**City of Bellevue
Development Services Department
Land Use Staff Report**

Proposal Name: Verizon Wireless – SEA Ardmore Park

File Number: 10-107029-LA

Recommendations Included: Administrative Conditional Use Permit (Process II, Land Use Code 20.30E)

Zoning Map

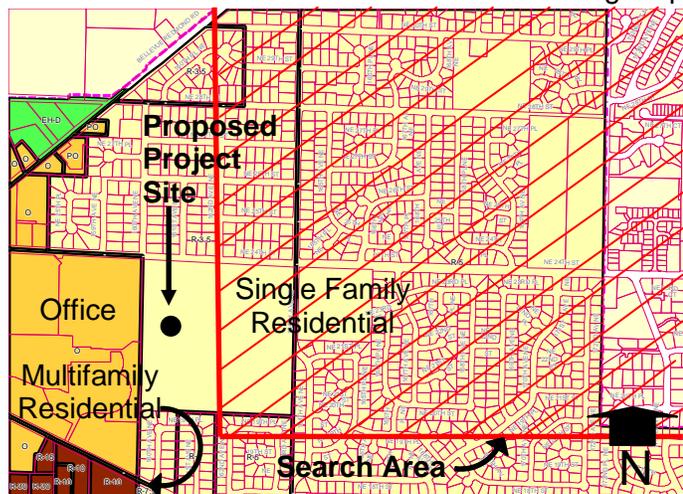
Question/Comment #1: Was a search ring and zoning map showing all zones available in the coverage gap submitted with this application? Also, did Verizon consider locational hierarchy as required by the Land Use Code? Were other possible locations considered outside the single family residential zoning district?

Response: A zoning map with the coverage gap overlaid on it is embedded on page 2 of this staff report. The coverage gap area is all single family zoning; there are no non-residential and/or multi-family zoning districts within the search ring. Commercial and multifamily zones west of the coverage gap area are too far away to meet Verizon's minimum service requirements.
